Product Upgrade Bulletin 191010REV

PRODUCT(S) AFFECTED:
American Eagle, equipped with Option 455, Foil Cabinetry and having the microwave installed below a cabinet

SUBJECT:
Shimming the Microwave Mounting to Improve Ventilation

ISSUE DATE:
December 2019

Figure 1

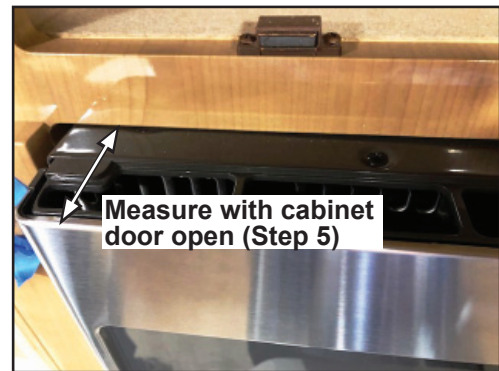
5. With the cabinet door open, measure the distance between the front face of the cabinet (above the microwave) and the front face of the microwave's door. If it is less than 3", the microwave's rear mounting bracket should be shimmed with plywood to allow clearance for proper venting. Refer to the photos in Figures 1 and 2 for examples of a microwave that needs shims added to its rear bracket mounting surface to allow its proper ventilation.

Figure 5

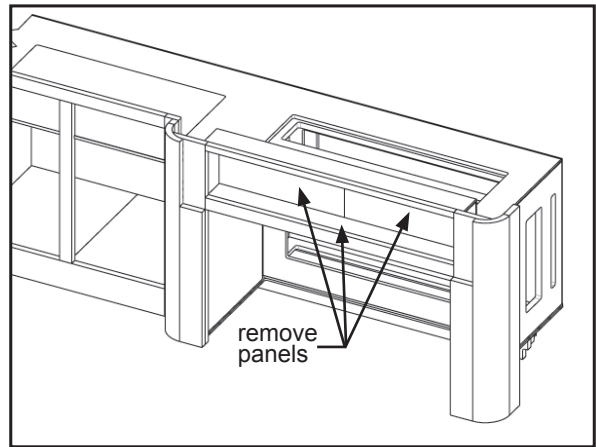
10. Remove the panels from inside the cabinet over the microwave by removing the panel screws. Retain screws for reinstallation. The microwave mounting screws should now be visible - **do not** remove them yet. See Figure 5.

Figure 8

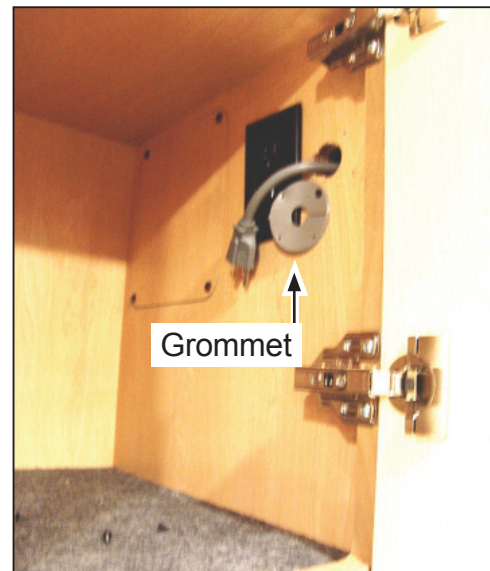
16. Reinstall the microwave mounting bracket using the original screws. The bracket should be aligned with the bottom of the plywood and centered horizontally, as shown in Figure 8.
17. Reinstall the microwave onto its mounting bracket using the original screws. Ensure the power cord is routed through the opening in the side of the cabinet when reinstalling the microwave.
18. Cover the opening for microwave's power cord using the original grommet. Plug the power cord back into the electrical outlet. Refer to Figure 8.
19. Reinstall the panels (removed in Step 10) in the cabinet above the microwave.
20. Return any contents removed from the microwave back into place and close its door.
21. Clean up the area and close the doors for the cabinets.
